NRL Report No. R-1374
BuEng Problem T5-26

NAVY DEPARTMENT
BUREAU OF ENGINEERING

Report on
Band Change Switch
of

Models TBO and TBO-1 Portable Radio Equipment
General Electric Company
Contractor

Plate 1

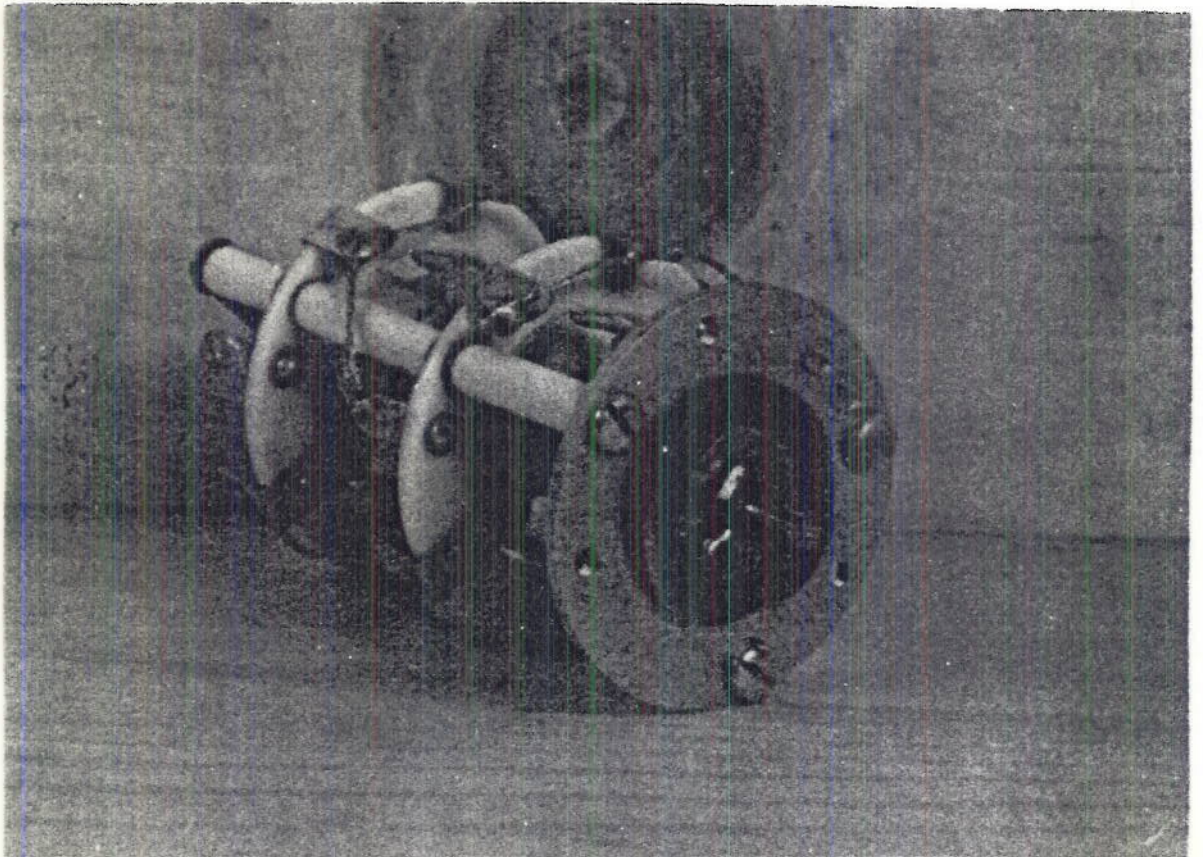
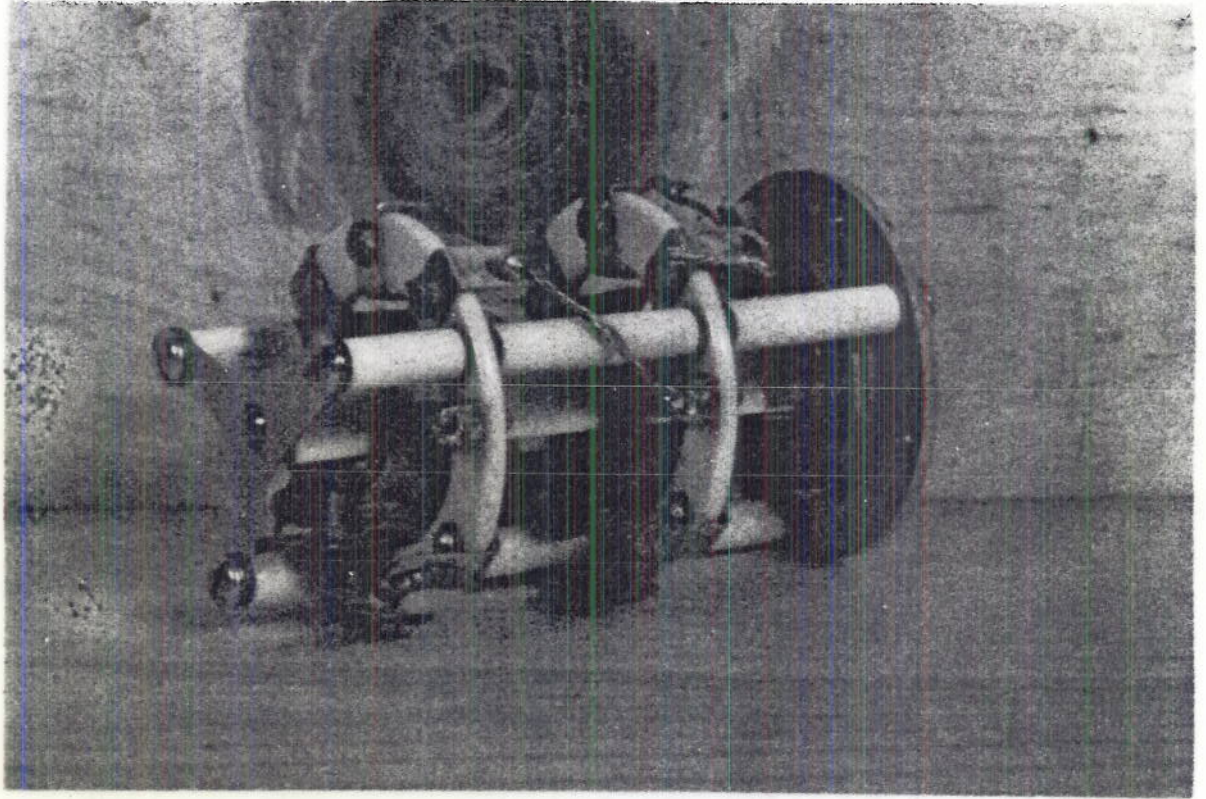
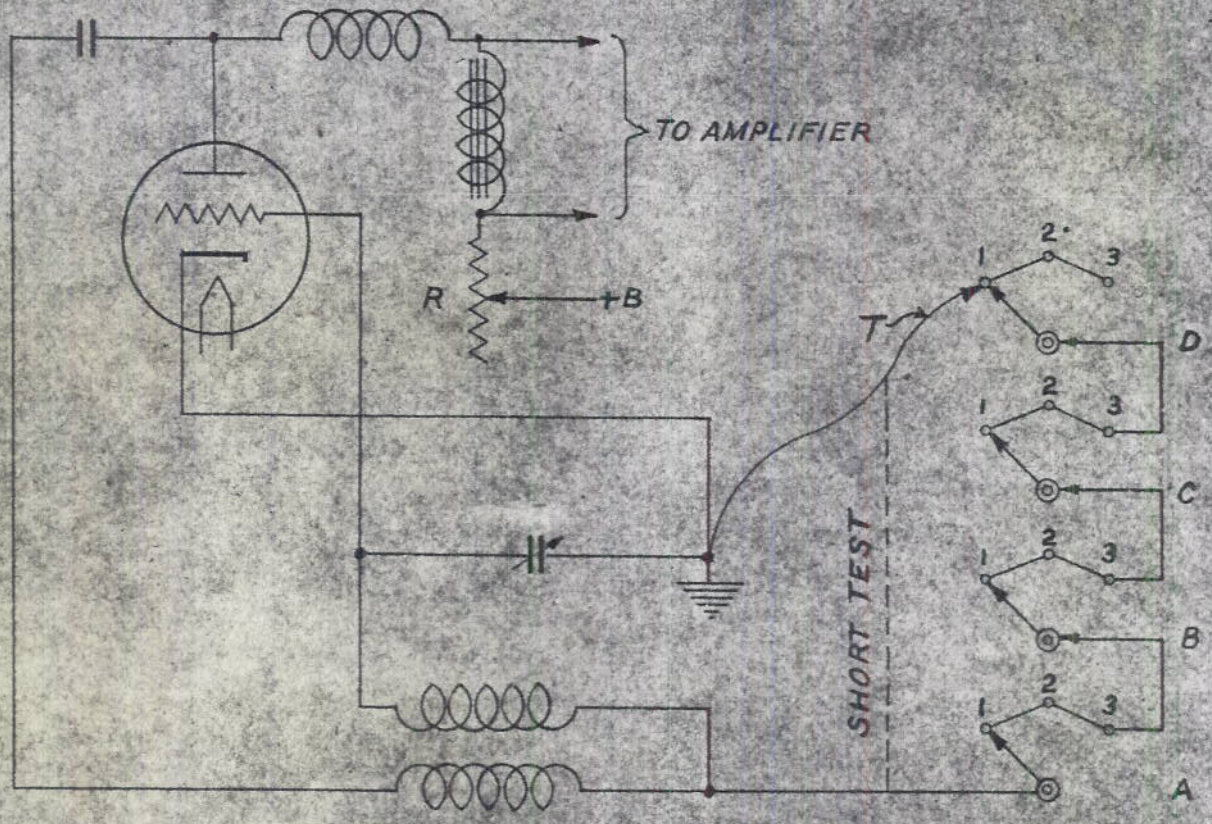
Photographs were then taken to show that the spring washer previously mentioned as binding on the cotter pin was broken in three places.

38. If, during the tests, the degree of rotation had been limited to that allowed by the stops provided, the clicker washer would not have been cracked. The principal defects are that of the silver plating wearing off the rotor contacts and the excessive wear of these contacts themselves.

40. The breakage of the spring washer can not be considered as a defect as it was the result of rotation greater than the normal 90° rotation required for the three positions provided. It was caused by abnormal strain as the cotter pin head passed the clicker ball positions when 360° rotation was effected as in these tests. It is probable, however, that this would become a defect should this switch be employed for a greater number of steps requiring greater than 90° rotation unless the present cotter pin is replaced with some form of securing pin that does not contact the washer in rotation.

41. The silver plating on the spherical tips of the rotor contacts definitely wears off with relatively few switch operations.

(a) The clicker spring washer be silver plated or plated with some material that will retard corrosion.

(b) The rotor contacts be made of some material that will better resist wear and that this material be non-corrosive.

(d) The ring contact springs be soldered to their terminal lugs.
